MANUFACTURED HOUSING CONSENSUS COMMITTEE

MINUTES MANUFACTURED HOUSING CONSENSUS COMMITTEE (MHCC) MEETING

October 18-20, 2022 & November 15-17, 2022

Continued Review and Modification of Working Document: Modifications to MHCSS based on DOE Final Rule

With Updated Costs, 10-Year Tier 2 LCC Negative For Most of the Country

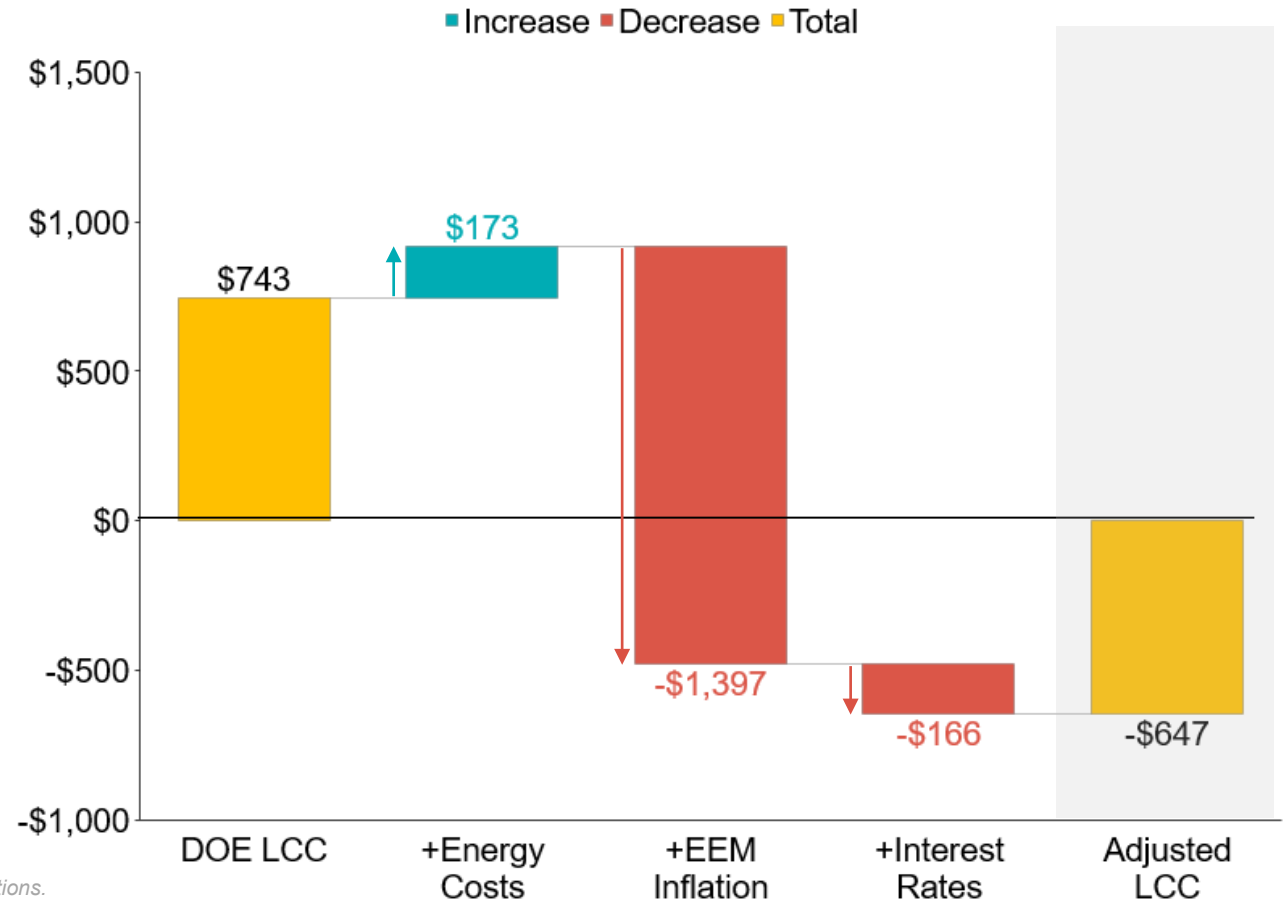
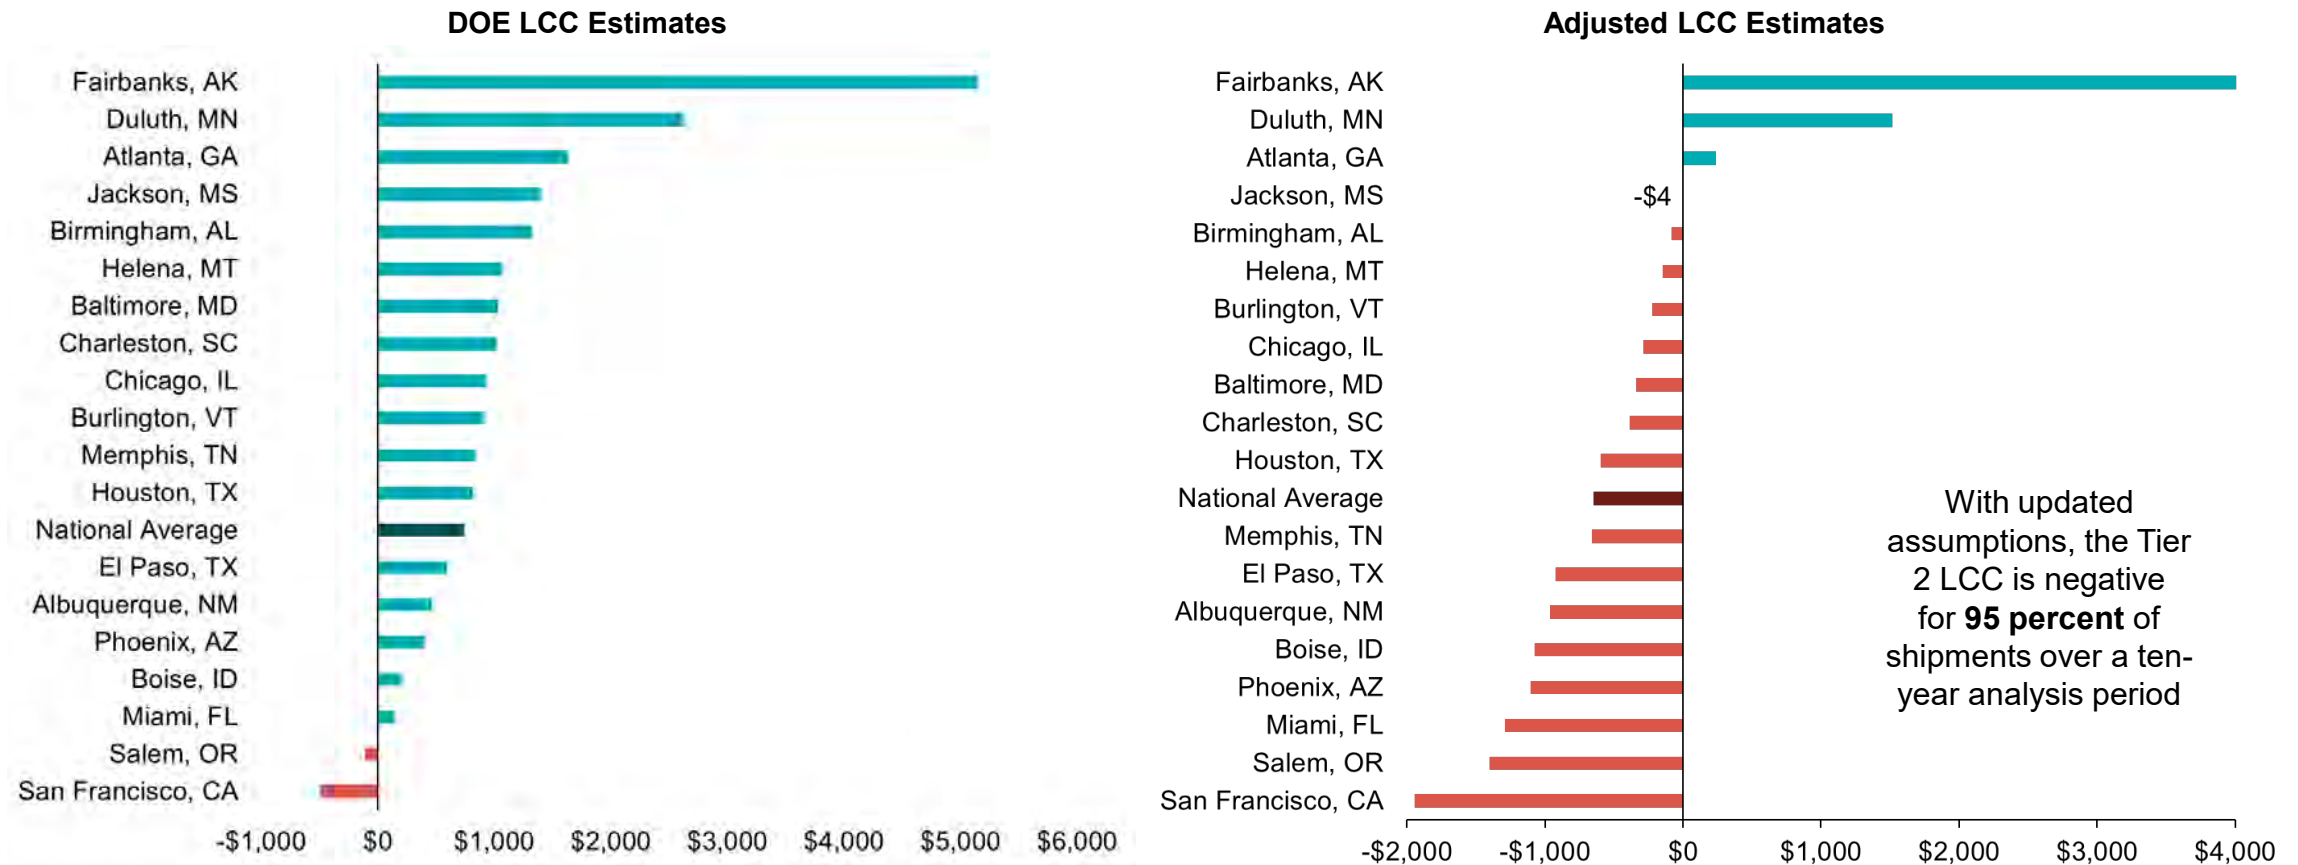
With updated assumptions, the Tier 2 LCC is negative for **95 percent** of shipments over a ten-year analysis period

IMPACT DUE TO DOE PROPOSED MULTI WIDE – BOX SIZE 27x56

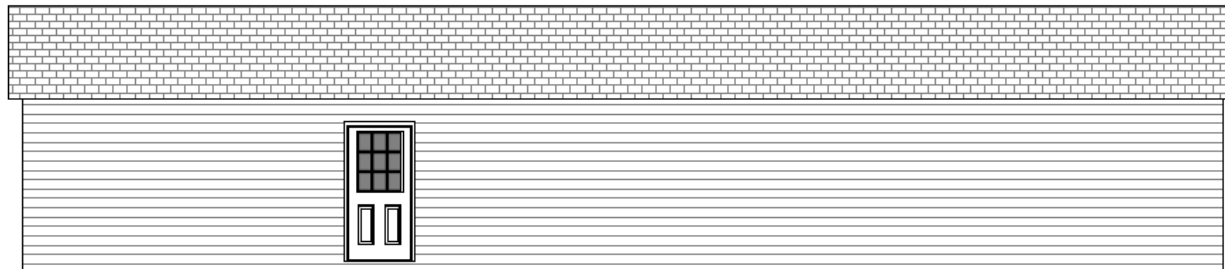
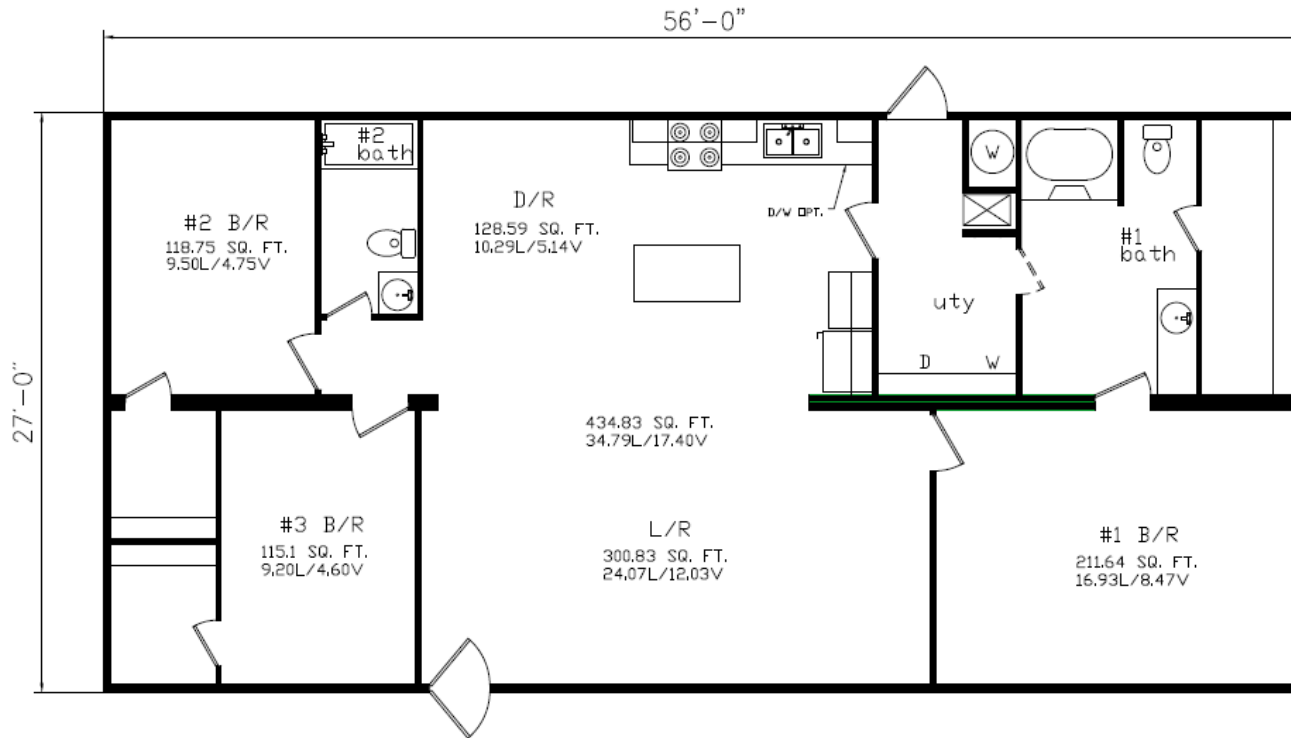
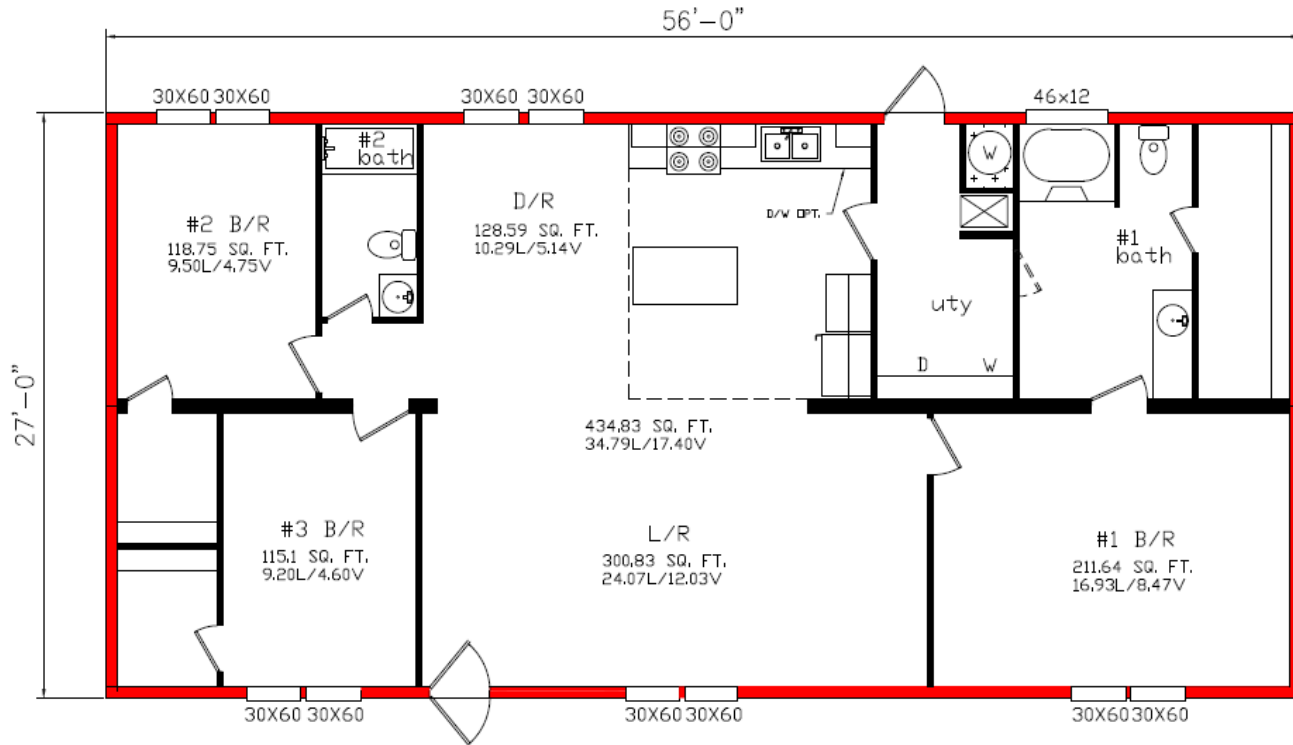
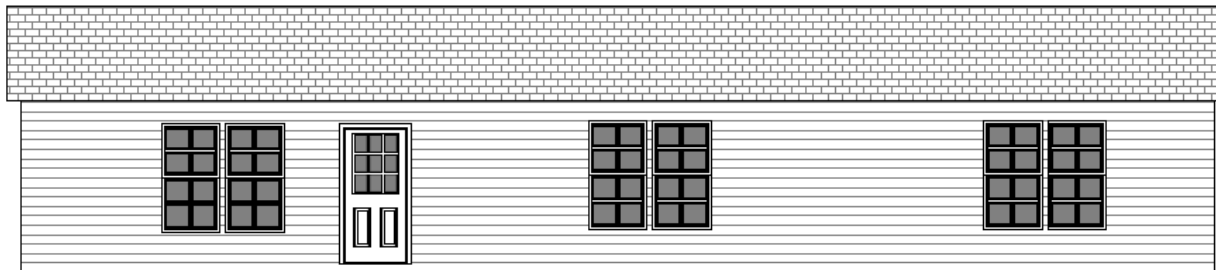
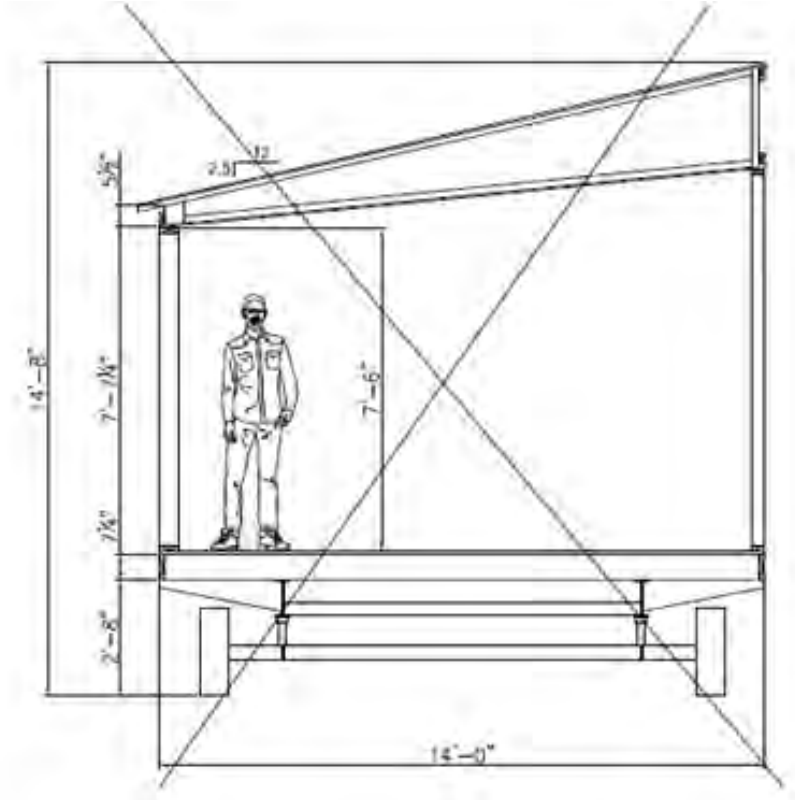
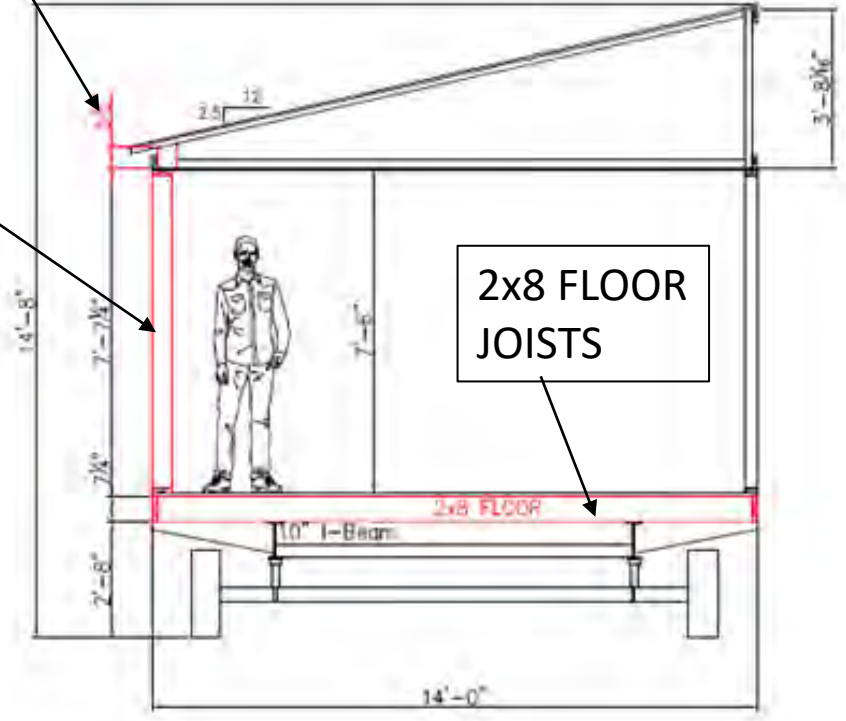
PROPOSED ZONE 3 CONSTRUCTION
INSULATION – 33 FLOOR / 15 WALL / 28 CEILING
2x4 WALLS
2x6 FLOOR JOISTS
ZERO WINDOWS
WINDOW U-VALUE = 0.32

ZONE 3 CONSTRUCTION: SHIPPING HEIGHT INCREASED TO 14'-8"
OPTIONAL VAULT CEILING IS NO LONGER AVAILABE DUE TO INSULATION THICKNESS
7'-6" SIDEWALL HEIGHT
5-1/2" TRUSS HEEL HEIGHT
2x8 FLOORS

IMPACT DUE TO DOE PROPOSED MULTI WIDE – BOX SIZE 27x56

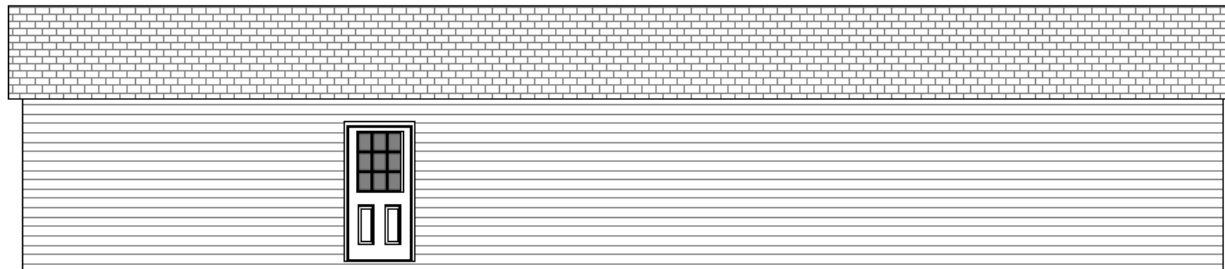
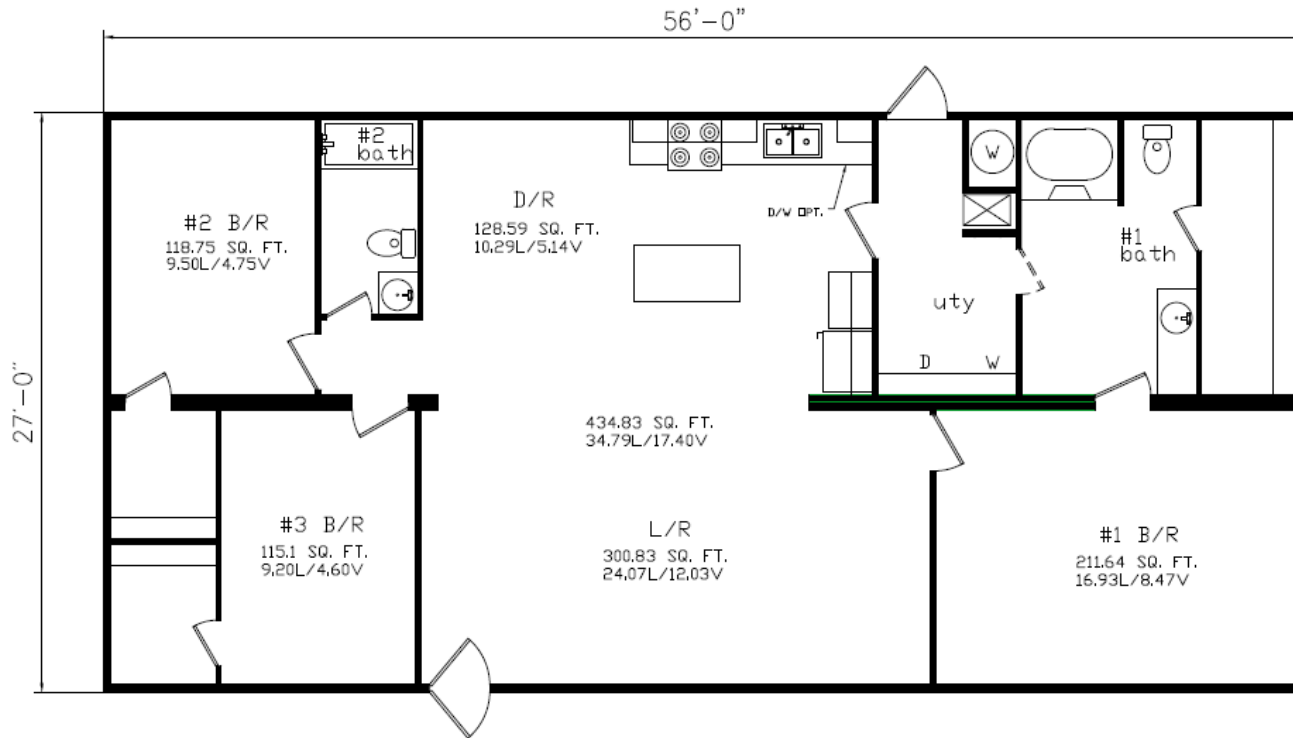
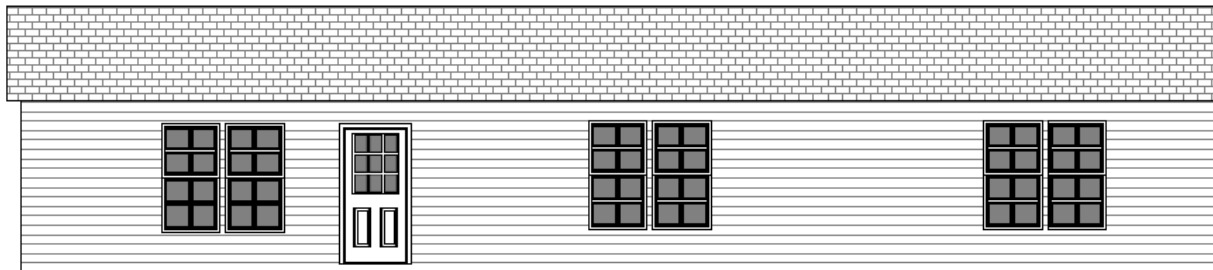
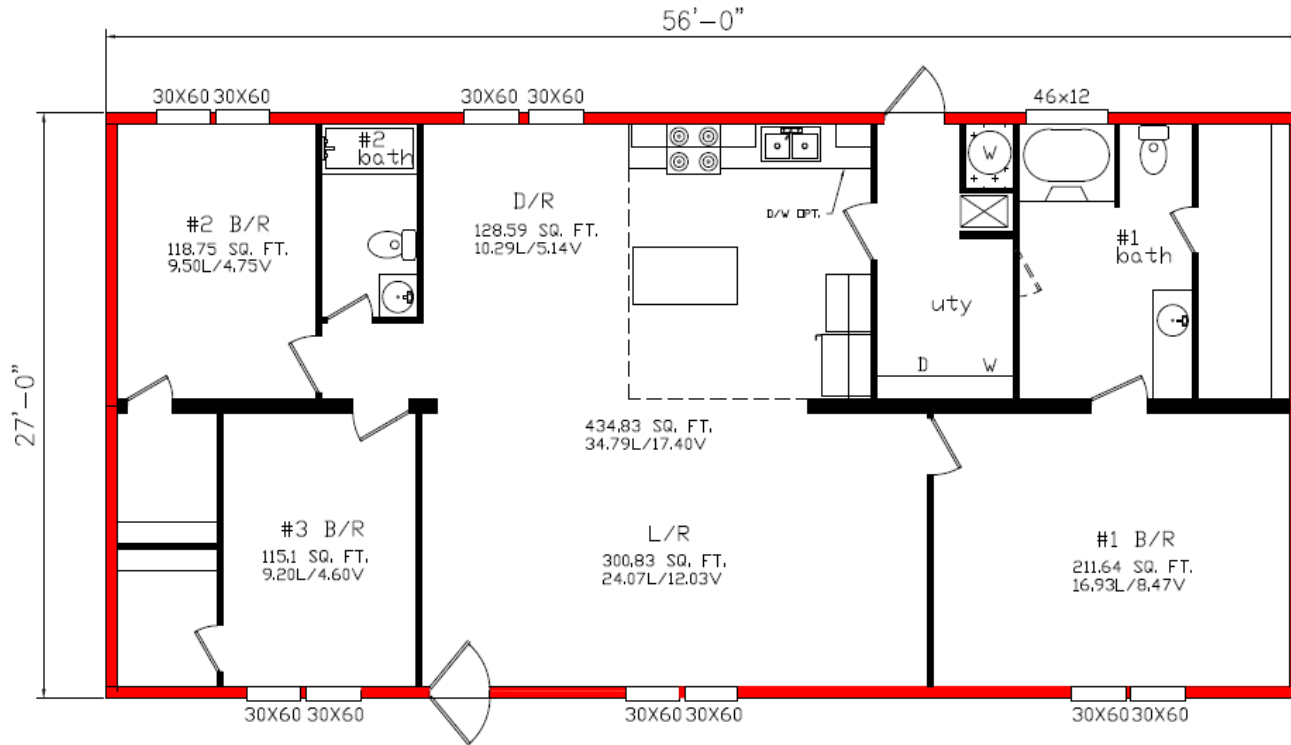
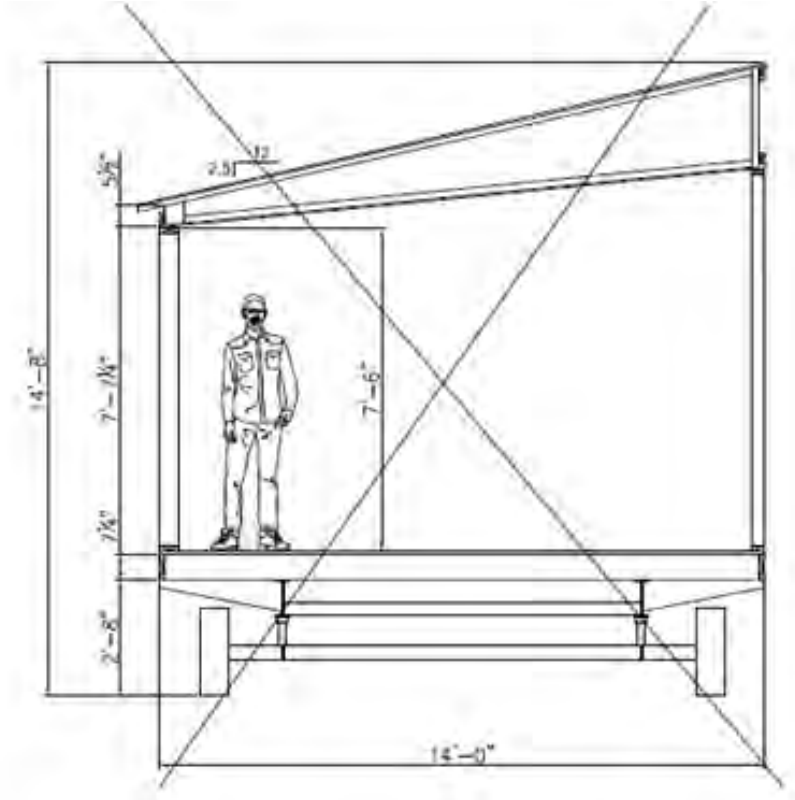
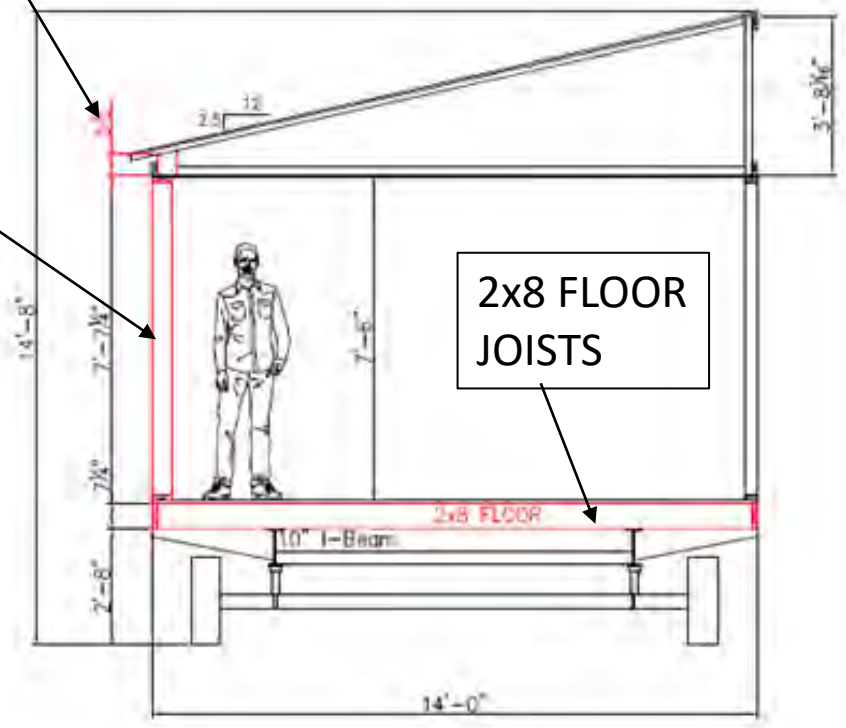
- IN ORDER TO REACH THE REQUIRED U-VALUE (0.55) THE FLOORS WERE CHANGED TO 2x8 , THE WALLS WERE CHANGED TO 2x6 AND THE INSULATION PACKAGE WAS CHANGED TO THE VALUES LISTED IN THE PRESCRIPTIVE SECTION OF THE PROPOSED CODE. HOWEVER, IT WILL BE VERY DIFFICULT TO BUILD THE HOME WITH THIS INSULATION PACKAGE USING CURRENTLY AVAILABLE MATERIALS.
